Planning and Land Use Department Planning Commission Staff Report

Cases Nos:	2023-(7079), (7662) & (7663)	
Hearing Date:	May 2, 2024	
Applicant:	Advanced Acquisitions, LLC	
Requests:	Development Plan, Variance from SFCC 14-5.5 (B)(4)(iii) CRHC & Variance from SFCC 14-8.2(D)(2)(b) Terrain Management	
Location:	27794 W I-25 Frontage Road	
Case Mgr.:	Daniel A Esquibel	
Zoning:	C-2 (General Commercial)	
Overlay:	Suburban Archaeological Review District	
Pre-app. Mtg.:	June 23, 2022	
ENN Mtg.:	May 03, 2023 & September 14, 2023	
Proposal:	Applicant requests development plan approval for a 141-dwelling multi-family development totaling 186,600 square feet of new construction with variances to SFCC 14-5.5 (B)(4)(iii) CRHC (setback) and 14-8.2(D)(2)(b) Terrain Management (30% slopes). The Property is approximately 19.26 acres.

2023-7079 Bungalows on Cerrillos Development Plan. Orion-West LLC., Agent for Advanced Acquisitions LLC, Applicant, requests Development Plan approval to construct approx. 186,600 square feet of new construction for a 141-unit multi-family one and two-story housing development. The subject property is approx. 19.26-acres and located at 27794 W I-25 Frontage Road, wit

Figure 4 CRHC Zone 4 Setback

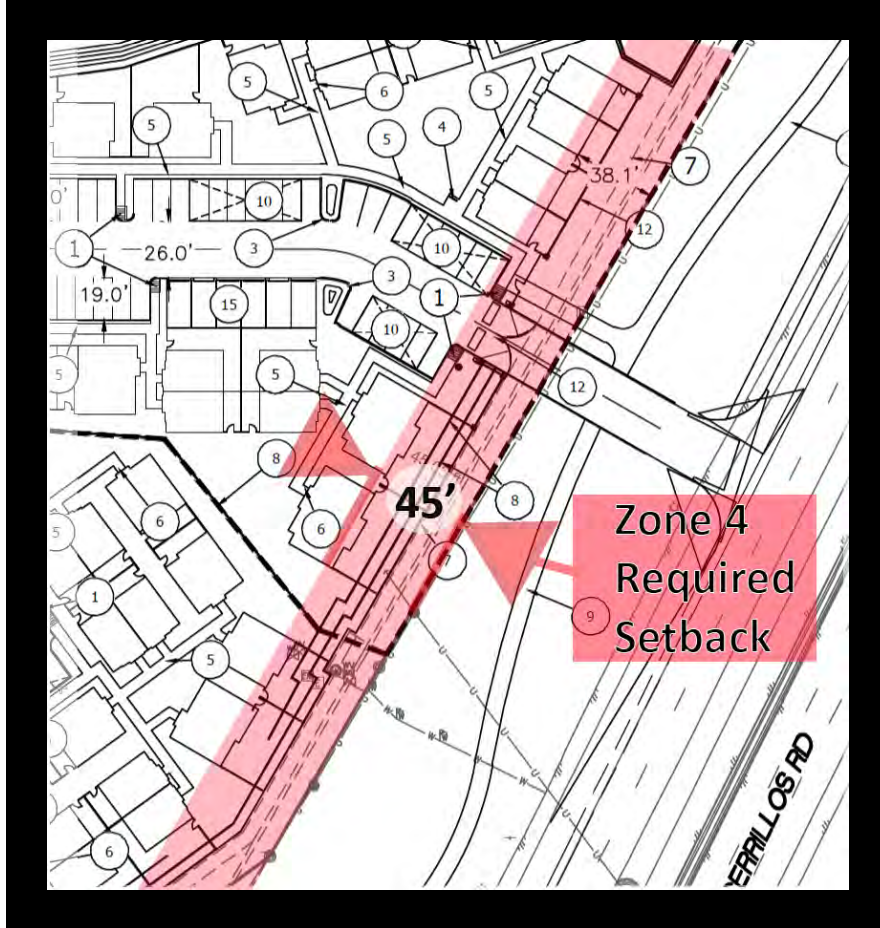
The Applicant also requests a variance to allow a 34-foot setback from the Cerrillos Road Right-Of-Way, where the required setback in a Zone 4 CRHC District is 45 feet (reference Figure 4 “CRHC Zone 4 Setback”). The variance is a six (6) foot reduction resulting in a 34-foot overall setback for the CRHC Zone 4 District for this property. The Planning Commission will need to determine whether to vary the regulations to accommodate the design of Development plan on a vacant tract of land or whether the design of the development plan should accommodate the regulations. The variance criteria are discussed later in this report (Table 8 “Variance Approval Criteria– Subsection 14-3.16(C) (Variance from 14-5.5(B)(4)(iii))”). Should the variance request be denied, staff would request the Planning Commission direct the Applicant to resubmit a new design complying with the CRHC Zone 4 Setback requirements for Staff review prior to recording the Development Plan.

Chapter 14 regulations and design standards do not qualify as "unusual physical characteristics" of a property. The applicant is proposing a sprawling multi-family complex with a design that requires waivers of the Code. There are other designs that can achieve the proposed density without requiring a variance to Variance from 14-5.5(B)(4)(iii).

Figure 5 Bicycle Parking

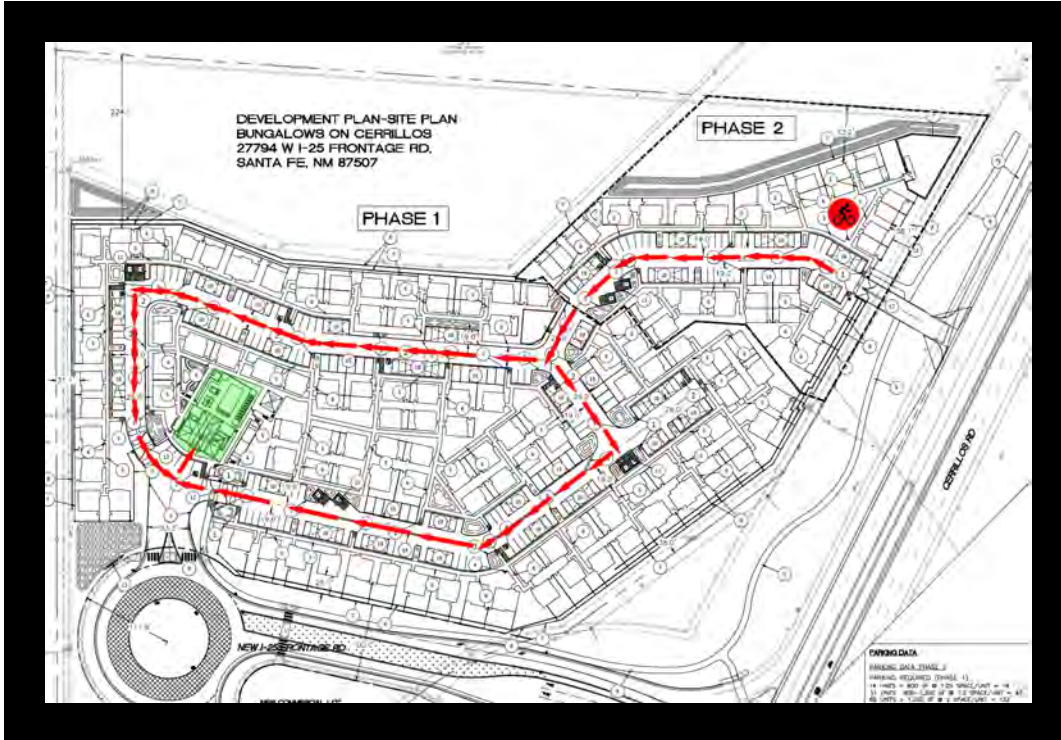
The Development Plan shows one location for bicycle parking with twelve (12) proposed bicycle parking spaces in phase 2 of the development. No additional information is included in the plan sets (Reference Figure 5 “Bicycle Parking”). It is not clear why the Applicant chose this location for bicycle parking. Staff finds that a better solution would be to redistribute the required bicycle parking at various destinations throughout the development including the club house and pool. This would allow tenants located furthest away from the clubhouse amenities to ride a bike to use the clubhouse amenities. Bicycle parking should be distributed to be in both Phase 1 and Phase 2 of the Development Plan.

6	The Applicant shall redistribute bicycle parking on the premises. Bicycle parking shall be included in both phase one and two. All bicycle parking shall comply with SFCC Chapter 14, Appendix, Exhibit D - Bicycle Rack Standards and Dimension.		
7	Primary access for the development is on New Mexico Department of Transportation (NMDOT) Frontage Road (see attached TIA approval letter from NMDOT with conditions to be met prior to issuance of building permit).	Wilson & Company / Leroy N. Pacheco, PE	Prior to recordation
8	The driveway on Cerrillos Road is for emergency access only. Plan Set to include a roadway signage and striping plan to be reviewed/approved by NMDOT and City Traffic Engineer for respective jurisdictions.		
9	An access permit shall be submitted to NMDOT for review and approval along with Roadway Improvement Plans for the project.		
10	Right-of-way will need to be dedicated to NMDOT by the property owner for the realignment of the Frontage Road.	NMDOT	Prior to construction

Figure 7 Trails and Open Space

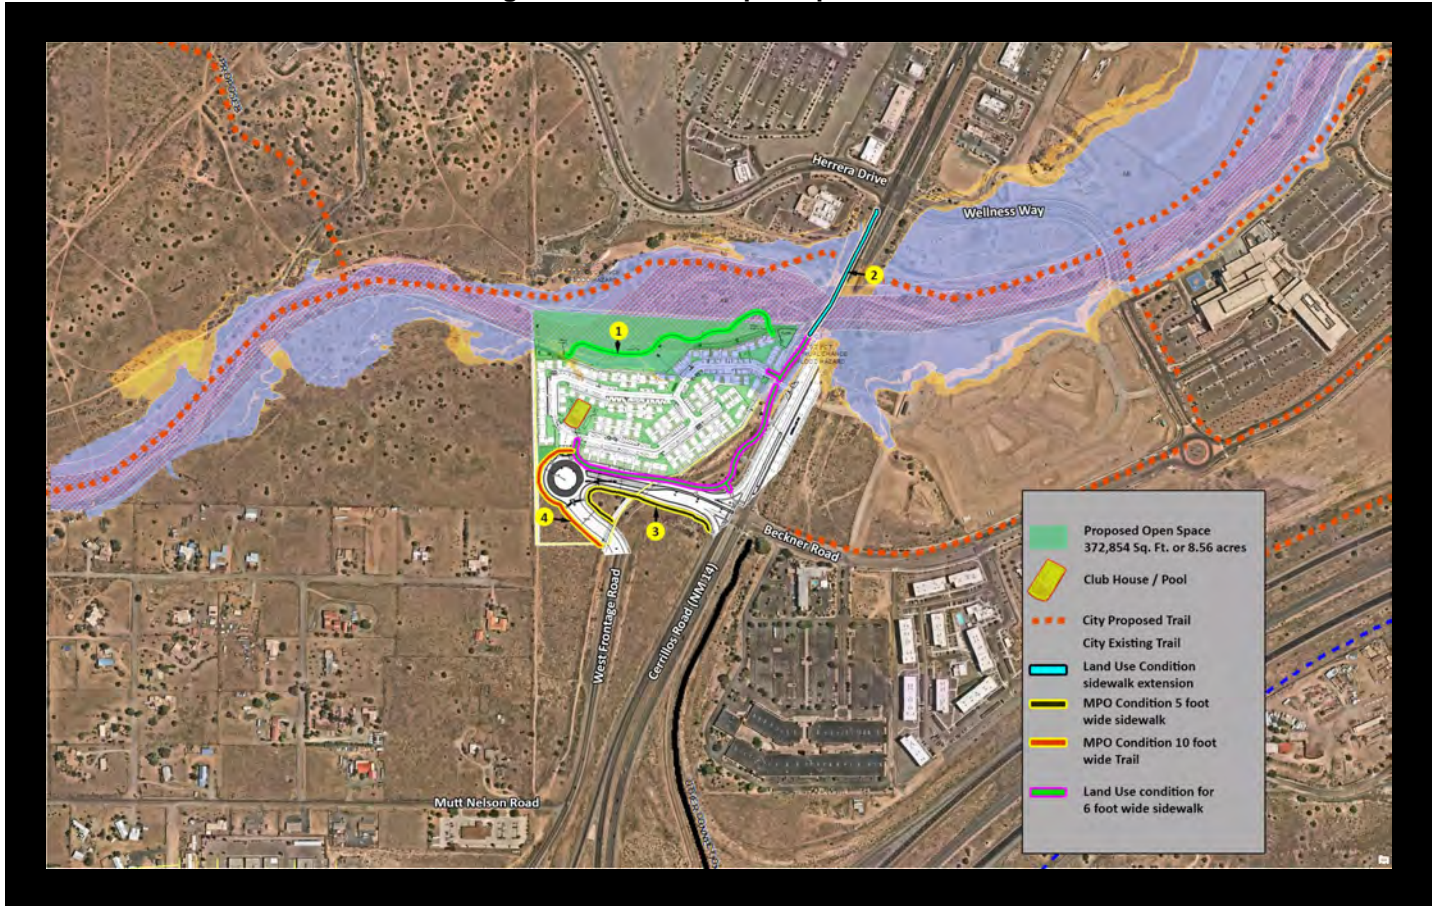
2. The Current Planning Division has requested a 6' sidewalk instead of a 10' wide trail along Cerrillos Road. The Applicant has committed to extending a six-foot-wide sidewalk from the main entrance, east along the Frontage Road, north along Cerrillos Road and linking to the existing sidewalk at Herrera Drive.

3. The MPO has requested a 5-foot sidewalk on the south side of the realigned West Frontage Road. The applicant will construct a five-foot-wide sidewalk on the south side of the realigned West Frontage Road.

4. The Metropolitan Planning Organization (MPO) has requested that the Applicant build a ten-foot-wide trail to the southern edge of their property. , The applicant is contesting the 10-foot wide Trail and is agreeing to an 8 -foot wide trail (see Figure 7, "Trails and Open Space").

11	Extend the north/south sidewalk parallel to Cerrillos to the intersection with Herrera Drive.		
13	Illustrate on the development plan a new sidewalk on the south side of the NM I-25 Frontage Road to conform to city street design standards	Santa Fe Metropolitan Planning Organization	Prior to recordation
14	Illustrate on the development plan a 10ft sidepath along the west side of the NM I-25 Frontage Road to the property line, as detailed in the Santa Fe Bicycle Master Plan		
15	Illustrate on the development plan pedestrian crossings to each leg of the roundabout		
16	Improve pedestrian crossing safety by illustrating on the development plan high visibility crosswalk markings on all legs of the Cerrillos/Beckner/Frontage intersection and adding a pedestrian refuge island to the southern crossing of Cerrillos.		
17	Redesign the right turn slip lanes onto and off of the frontage road to limit speeds to 15mph or less.

Figure 8 Utilities

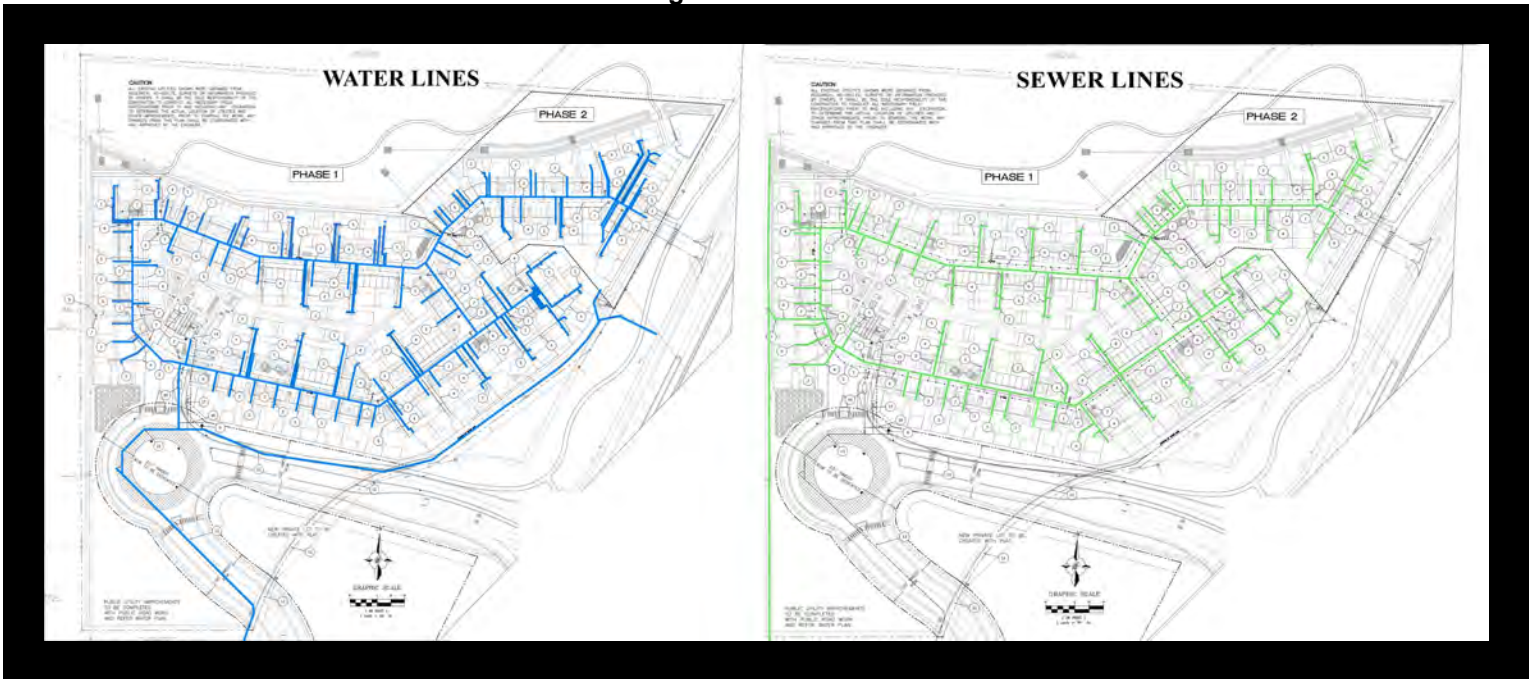
A 16" City water line runs under Cerrillos Road and around the I-25 W Frontage Road. The Applicant's preliminary water plan identifies an 8" extension off the 16" City (Public) water lines to 6" lines around the project road network. 6" lines will connect the apartments from the 8" lines within the development. The 6" lines will connect to Master Meters. From the Master Meters, 3" private lines will provide water service to the dwelling units. All water lines from the Master Meter to the dwellings will be maintained by the applicant. Dry utilities, such as electrical and internet were not addressed in the applicant's plans.

The Applicant will extend an 8" sewer line off an existing city (public) 8" sewer main running along the west edge of the property. From the public main the development will use 8", 6" and 4" lines to provide sewer service to the bungalow apartments. The sewer lines from the Public Main will be private and maintained by the Applicant. City Utilities Divisions comments can be found in Attachments A and B.

29	Proposed development layout based on the requested setback variance has a conflict with the existing water main and other existing water infrastructure. Should the setback Variance be approved, this conflict will need to be resolved by either relocating the existing water infrastructure or redesigning this portion of the development to avoid the conflict. Final changes needed to resolve this conflict must be reflected on the approved water plan.	City Water Engineering	At the time of development
30	Access to sewer manhole 1 is required. The sewer discharge of the entire project discharges to the City's public sewer system through manhole 1. In the event of a stoppage in this section of the sewer system and the City needs to respond, access would be required to manhole 1.		Prior to recordation
31	Show the location and the separation distance between the existing 24-inch sewer lines and the storm water discharge pipe in all profiles of the storm water system

Figure 11 30 Percent Slopes

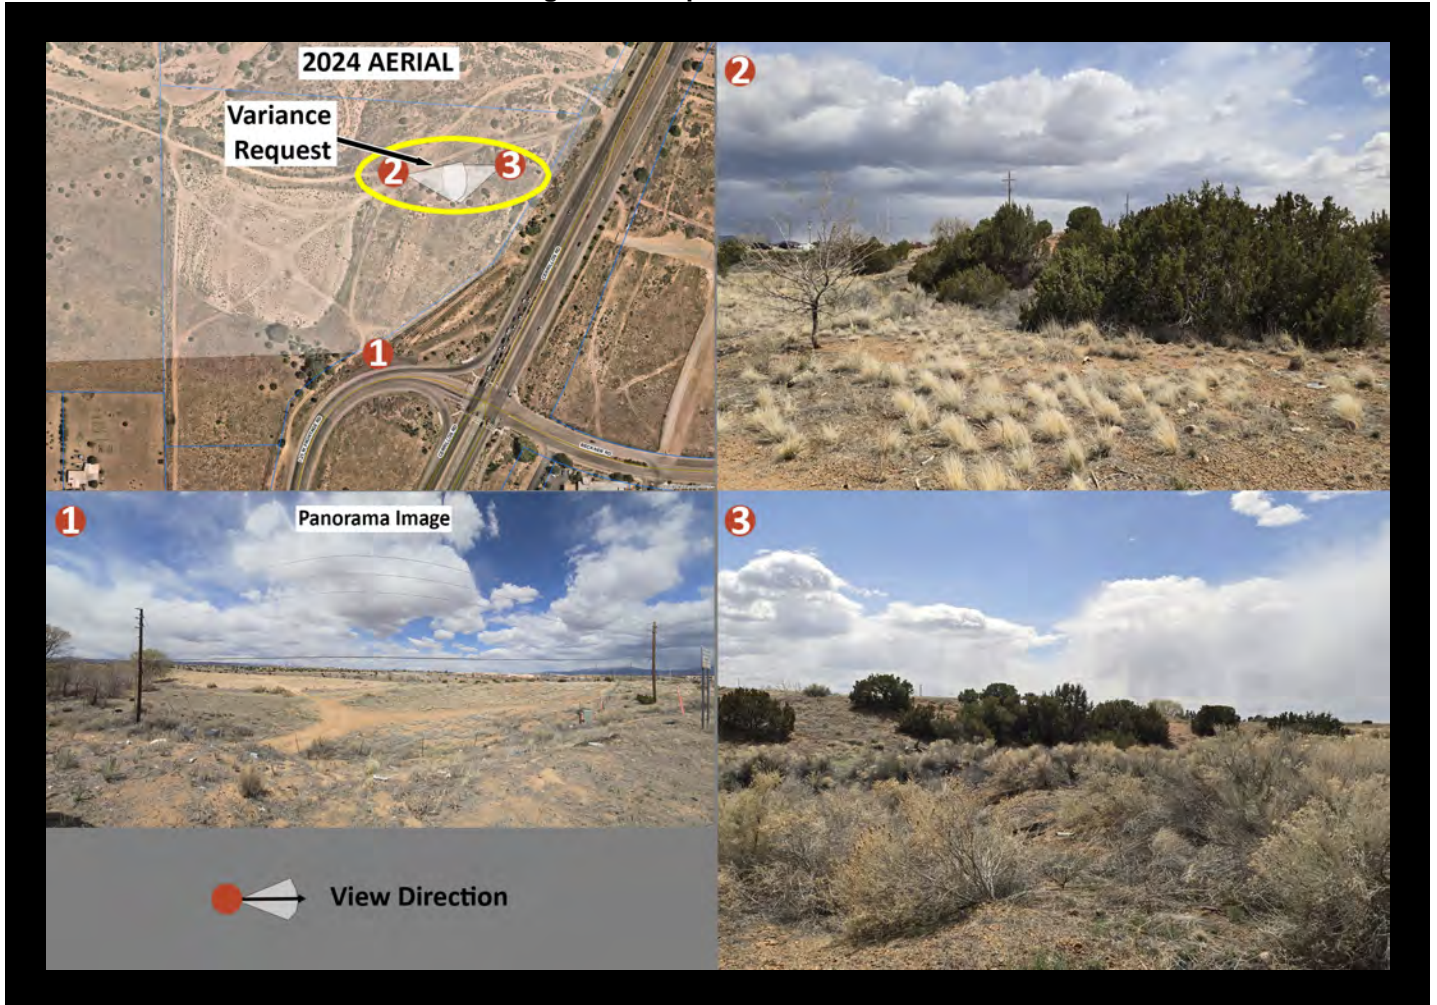
Terrain constraints are qualifying factors that present "unusual physical characteristics" of a property. However, the Applicant proposes a sprawling multi-family complex as opposed to vertical construction. The Commission will need to measure the constraint against the specific design of the development to determine whether the constraint poses an impediment or if an alternative design can effectively work around it, thereby eliminating the need for a variance.

Figure 12 Slope Variance

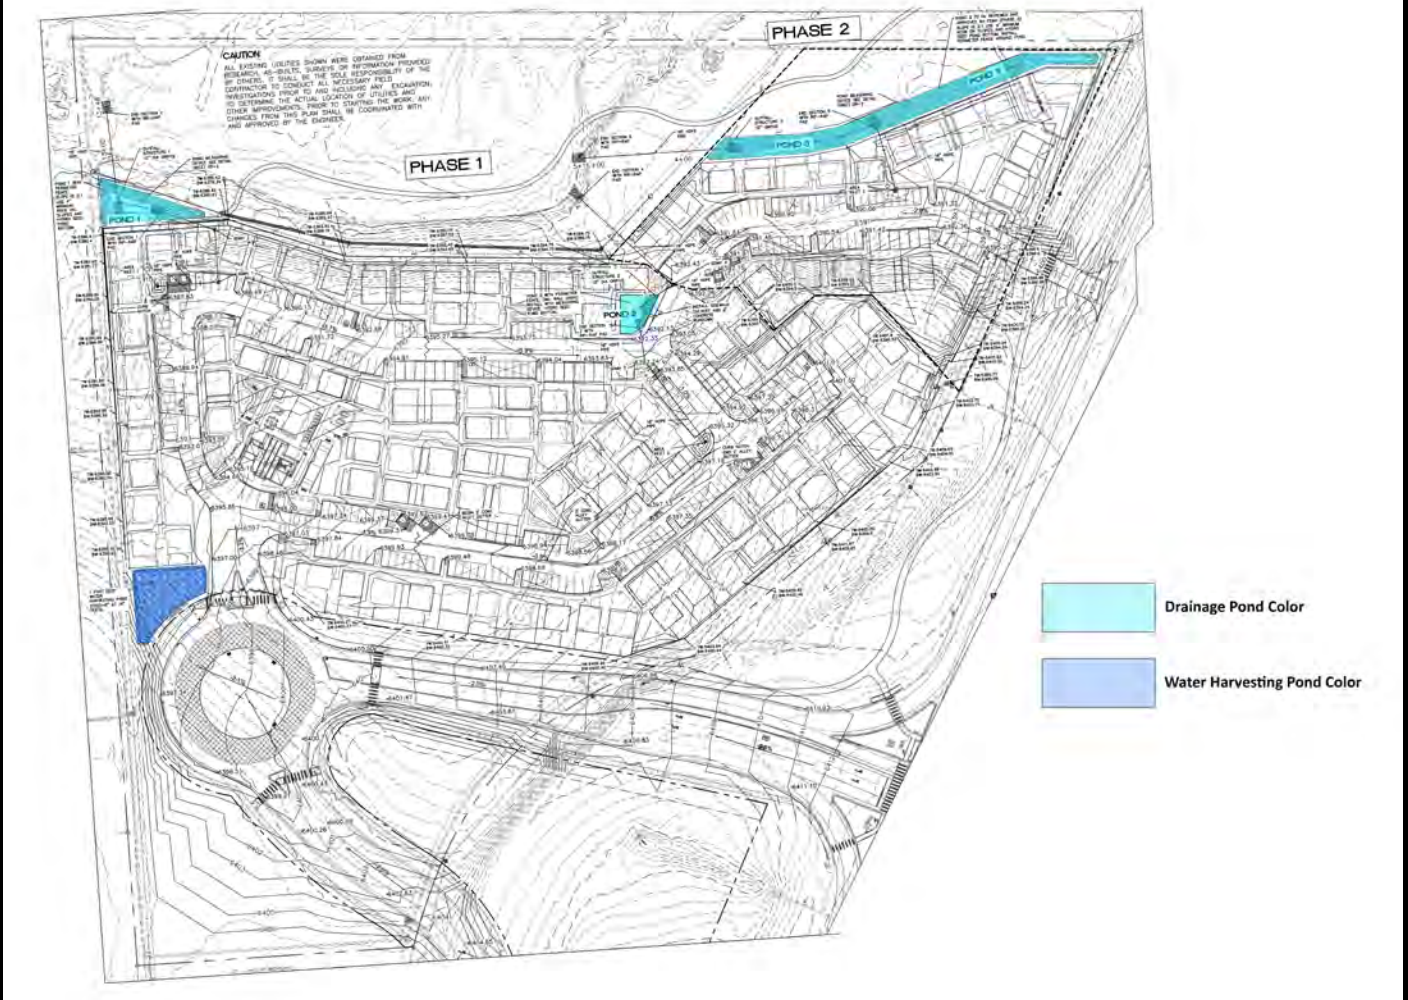
Staff's analysis identifies that the Applicant has not satisfied the variance criterion required by Subsection 14-3.6(C)(1). Alternative designs for the site could eliminate the need for a variance.

Figure 14 Architecture

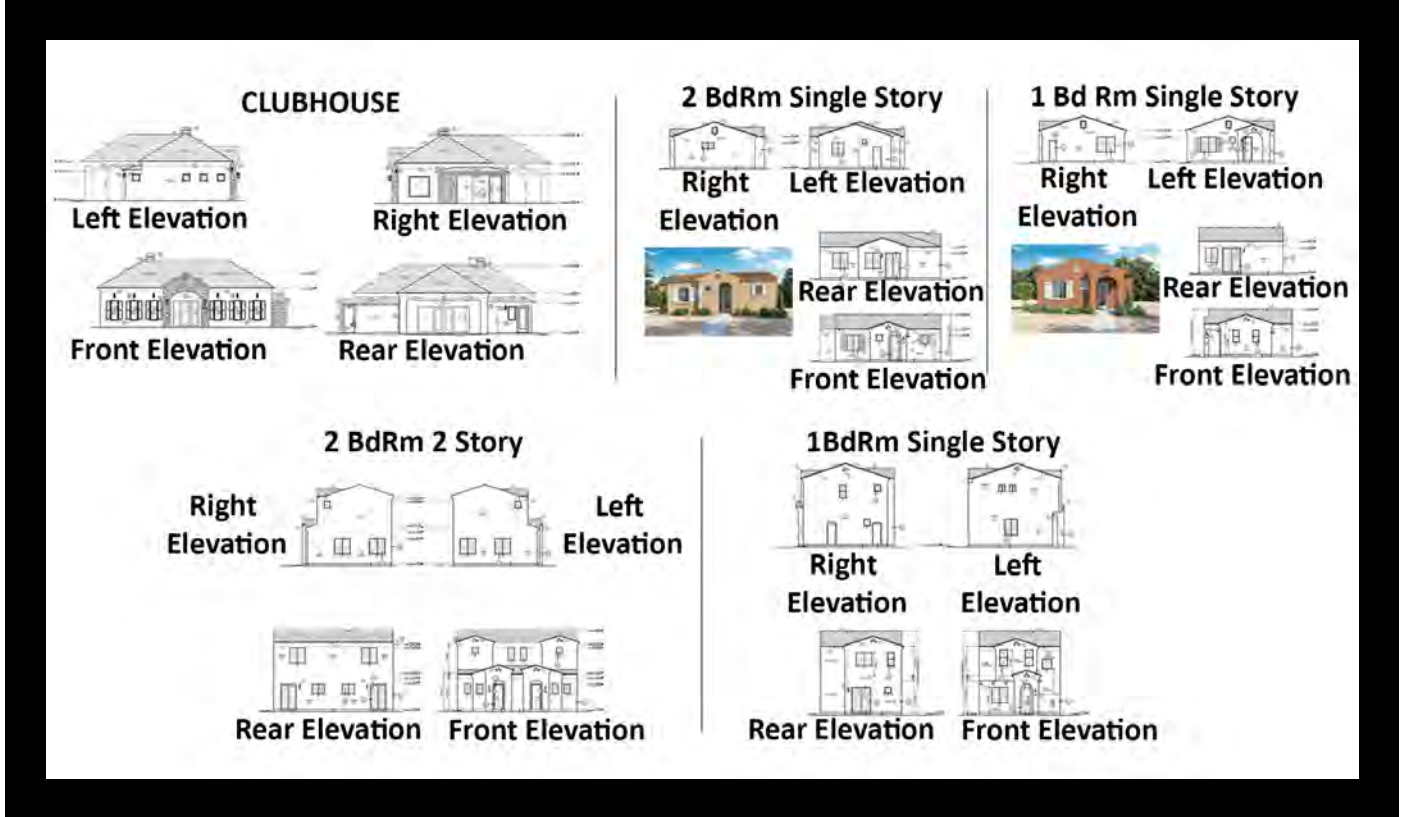
The Applicant’s mix of vernacular architecture style does not meet the unique Santa Fe Style typically pueblo or territorial or a vernacular of the two. If the Planning Commission’s decision is to deny the requested variances listed in Tables 7 and 8 in this report, the Applicant shall resubmit the application in compliance with Santa Fe City code Chapter 14.

Staff conditionally agrees with the Applicant’s response. The proposed multi-family complex design mimics the residential massing within the area; However, the architecture deviates from the traditional Santa Fe Style incorporating non-Santa Fe style of vernacular incorporating a mix of vernacular, mission, and bungalow style buildings. A condition of approval has been included within Section to address architectural style.
